ADDENDUM #001

Date: 6/4/2026

Blair Community Schools
Arbor Park Elementary School
Addition and Renovation
1717 Adams Street, Blair, Nebraska 68008

JJA Project: 3670
Drawings & Specifications
Dated: 5/18/2026

1 DEMOLITION WALL SECTION
AD3.1 3/4" = 1'-0"

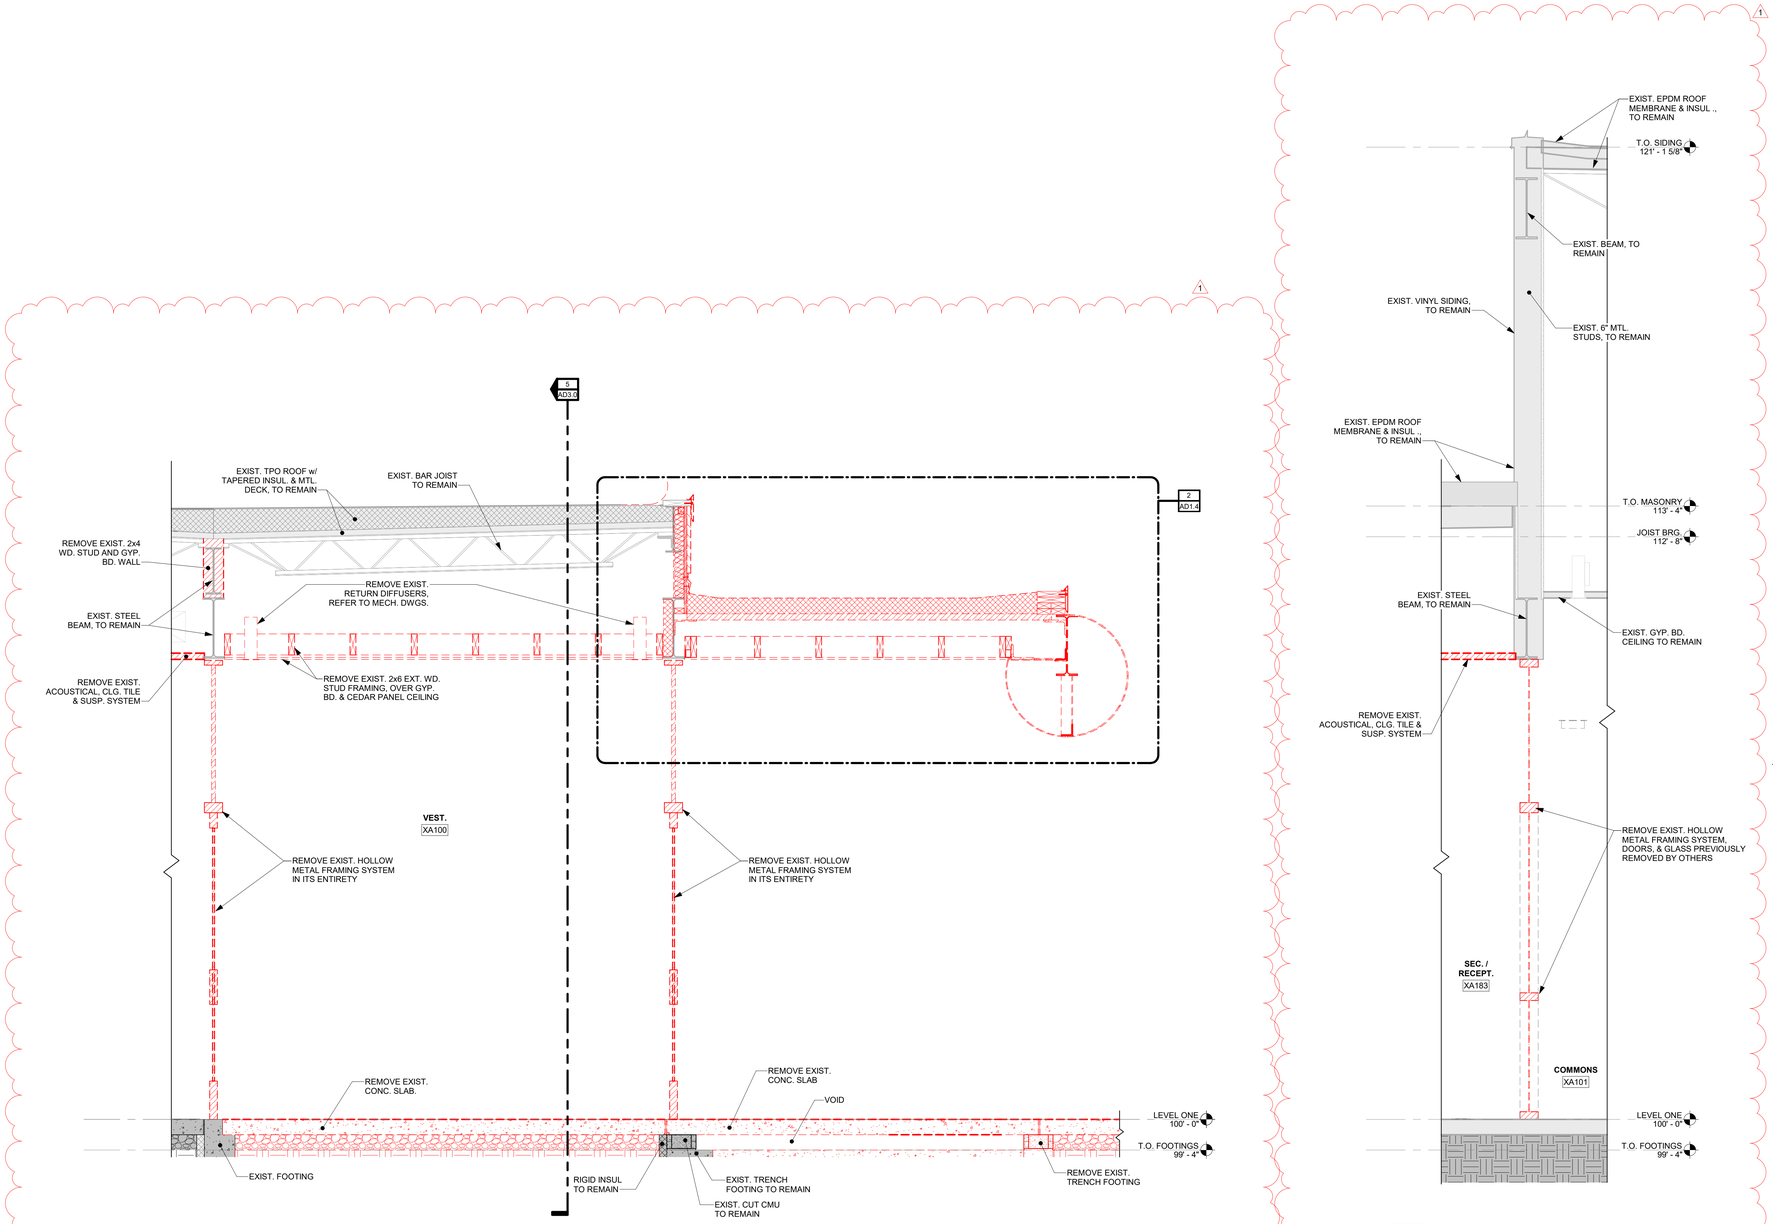
Item #17 Refer to Drawing AD3.1 – Demolition Wall Sections & Details and the attached revised drawing sheet.
A. Refer to the revised 1/AD3.1 Demolition wall section.
B. Refer to the revised 2/AD3.1 Demolition wall section.

1 LEVEL ONE FLOOR PLAN
A1.1 3/16" = 1'-0"

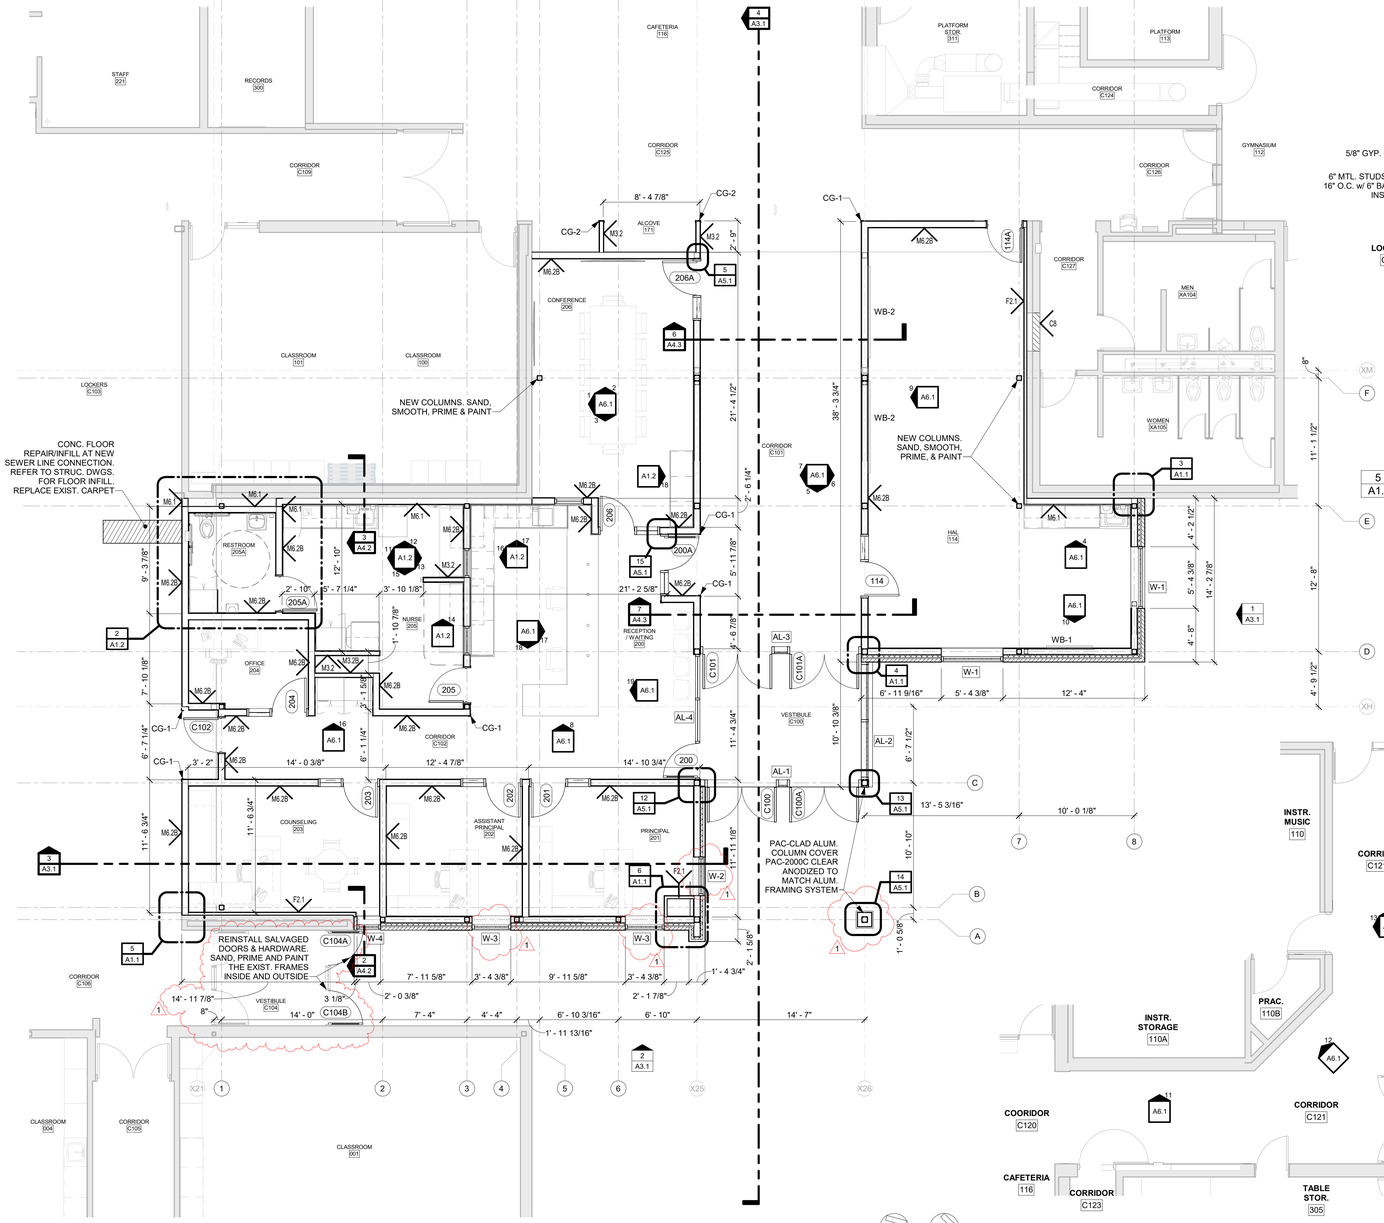
Item #19 Refer to Drawing A1.1 – Level One Floor Plan and the attached revised drawing sheet.
A. Refer to the revised 1/A1.1 Level One Floor Plan.
B. Refer to the revised 6/A1.1 Plan Detail @ Exterior Entrance.

12 NURSE 205 - WEST WALL
A1.2 1/2" = 1'-0"

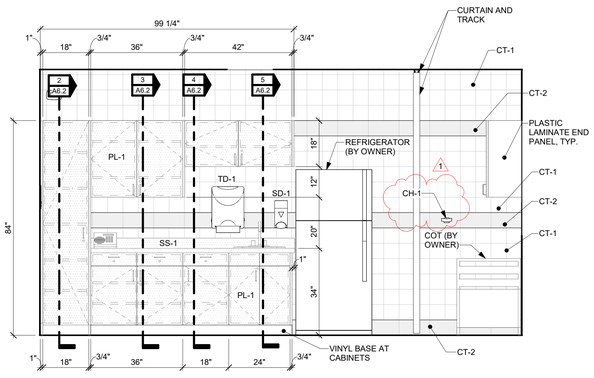
d. 10/A1.2 – Nurse 205A RR – South Wall
F. Refer to the revised 12/A1.2 Nurse 205 – West Wall elevation.
G. Refer to the revised 13/A1.2 Nurse 205 – North Wall elevation.

15 NURSE 205 - MILLWORK
A1.2 1/2" = 1'-0"

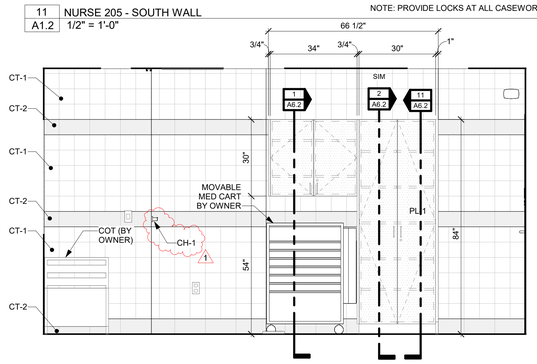
H. Refer to the revised 15/A1.2 Nurse 205 – Millwork elevation.
    a. Change the description to “Nurse 205 – East Wall” and refer to the revised elevation.

16 RECEPTION/ WAITING 200 - SOUTH WALL
A1.2 1/2" = 1'-0"

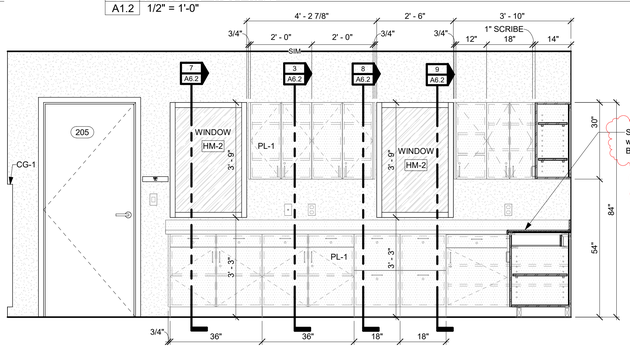
I. Refer to the revised 16/A1.2 Reception/ Waiting 200 – South Wall elevation.
J. Refer to the revised 17/A1.2 Reception/ Waiting 200 – West Wall elevation.

1	ROOF DETAIL
A1.3A	1 1/2" = 1'-0"

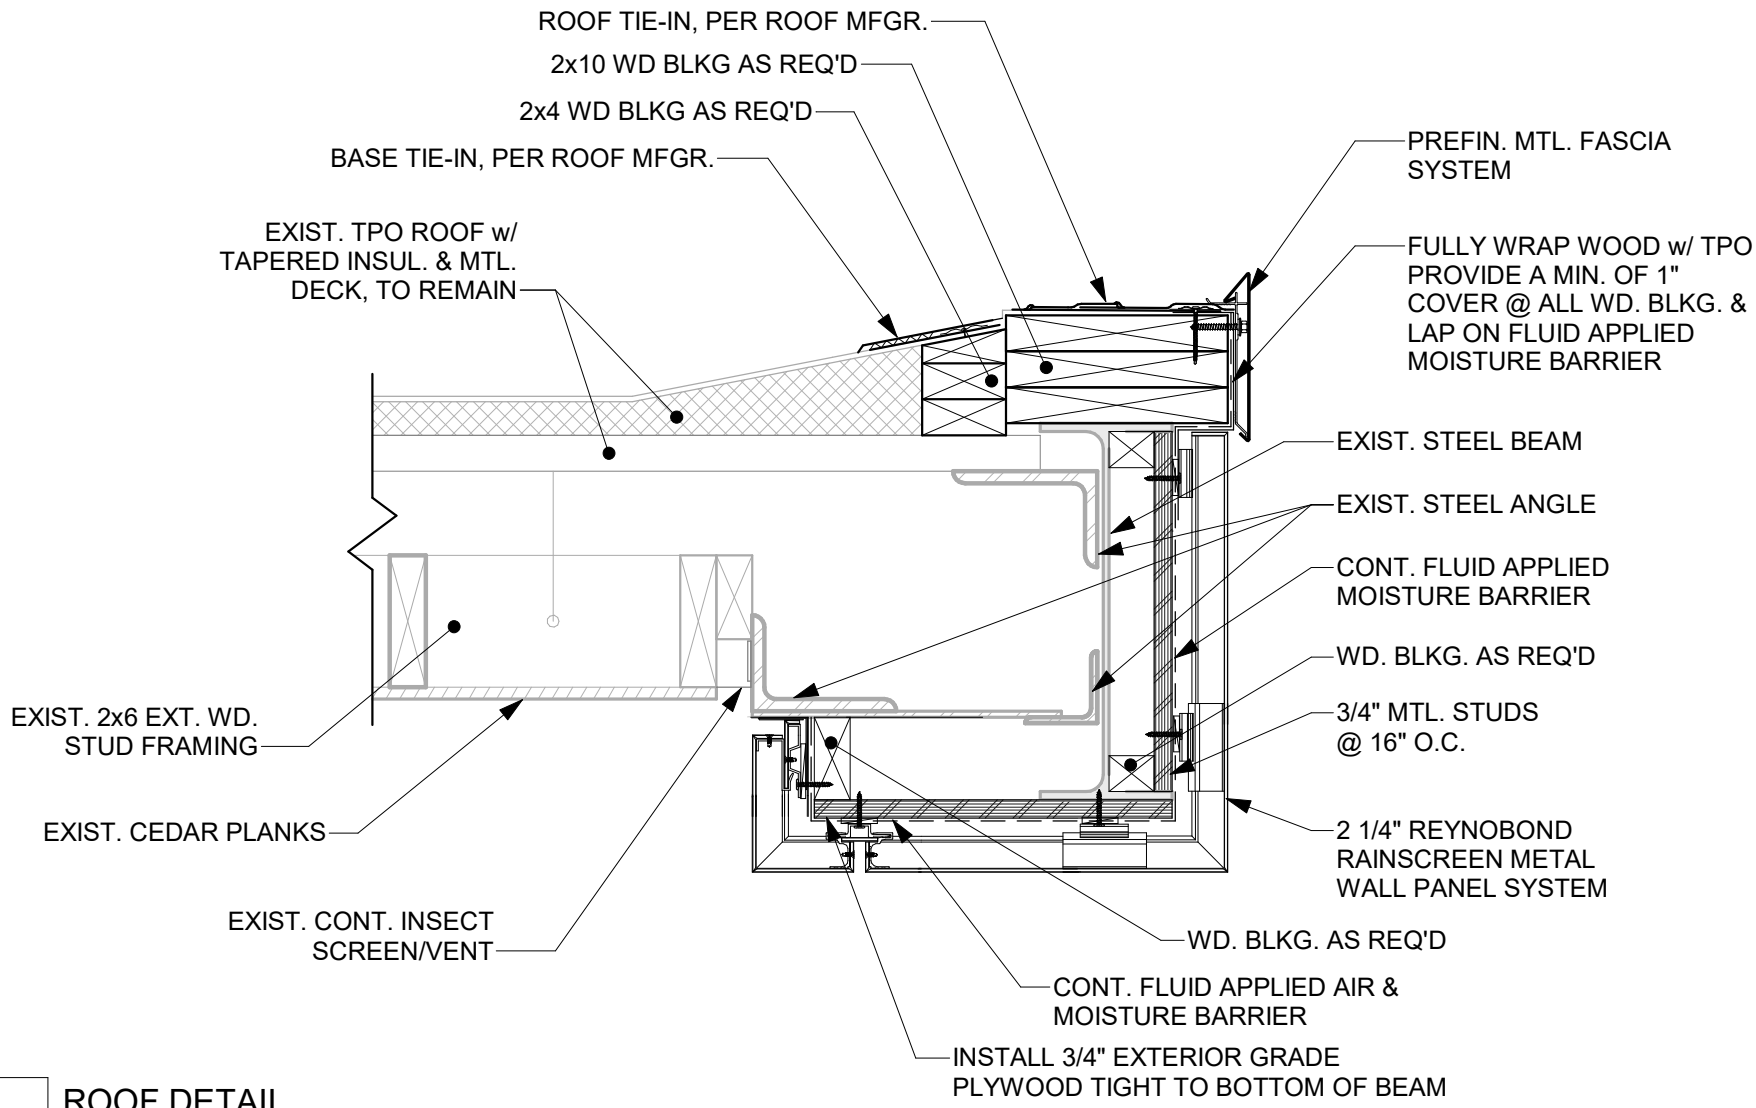
Item #22 Refer to the added Drawing A1.3A – ADD#001 – Roof Detail
A. Refer to the added 1/A1.3A Roof Detail.

1 NORTH ELEVATION
A3.1 1/8" = 1'-0"

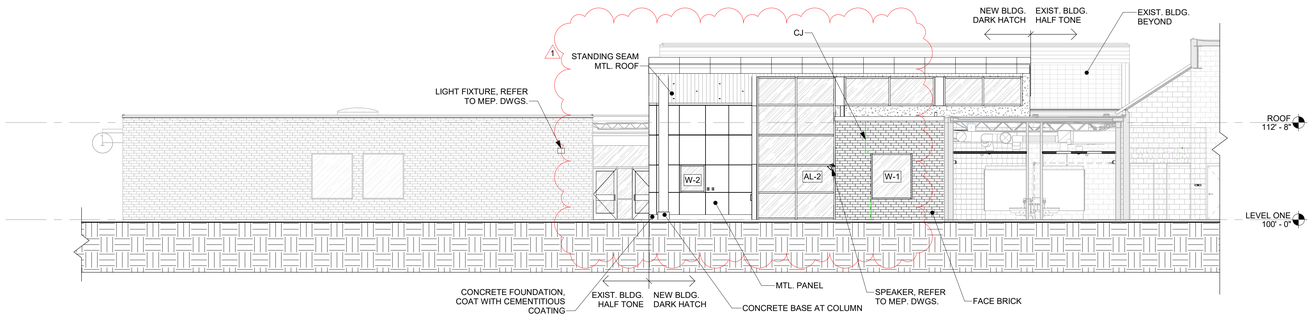
A. Refer to the revised 1/A3.1 – North Elevation.
B. Refer to the revised 2/A3.1 - East Elevation.
C. Refer to the revised 4/A3.1 – Building Cross Section East-West.

1 WALL SECTION
A4.1 3/4" = 1'-0"

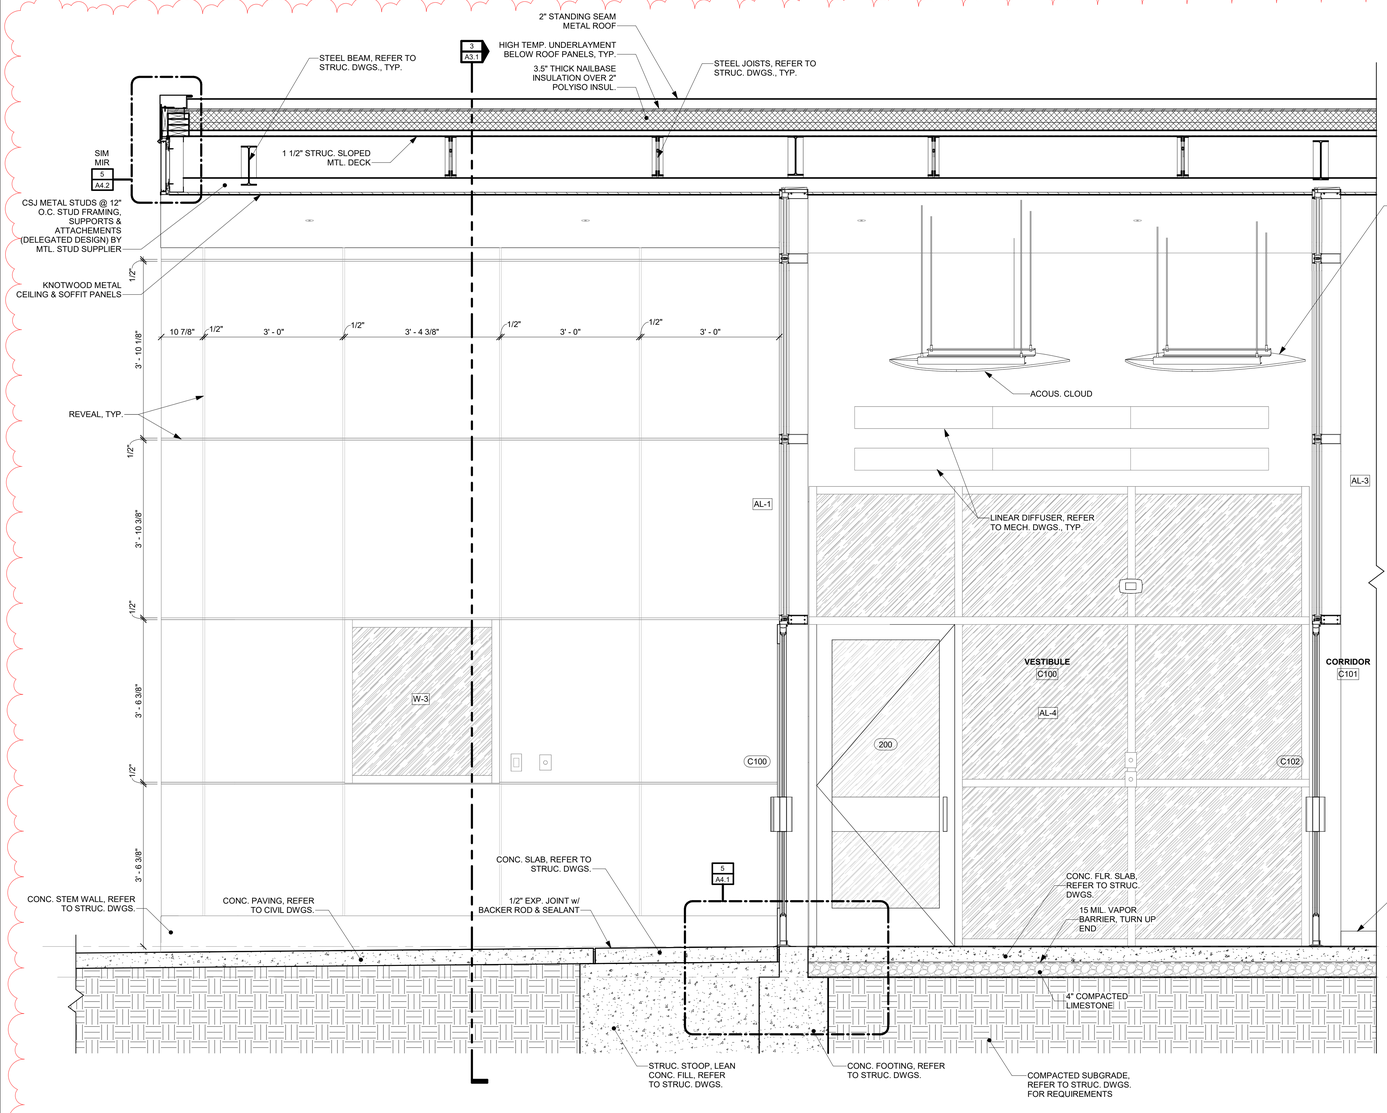
Item #24 Refer to Drawing A4.1 – Wall Sections and Details and the attached revised drawing sheet.
A. Refer to the revised 1/A4.1 Wall Section.
B. Refer to the revised 3/A4.1 Wall Section.
C. Refer to the revised 4/A4.1 Column Detail.
D. Refer to the revised 5/A4.1 Column Detail.

1 WALL SECTION
A4.2 3/4" = 1'-0"

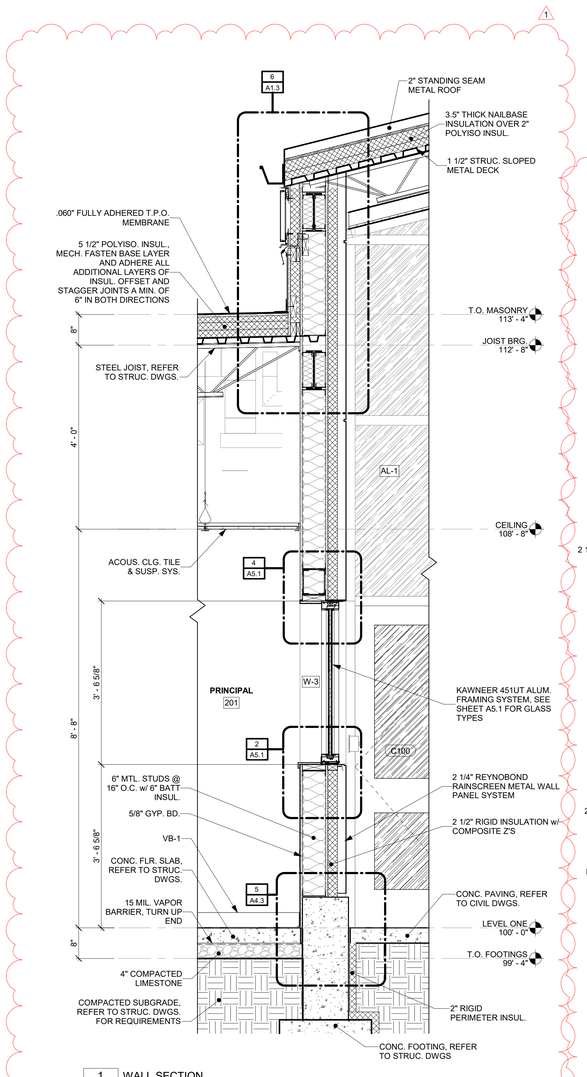
Item #25 Refer to Drawing A4.2 – Wall Sections and Details and the attached revised drawing sheet.
A. Refer to the revised 1/A4.2 Wall Section.
B. Refer to the revised 2/A4.2 Wall Section.
C. Refer to the revised 3/A4.2 Wall Section.
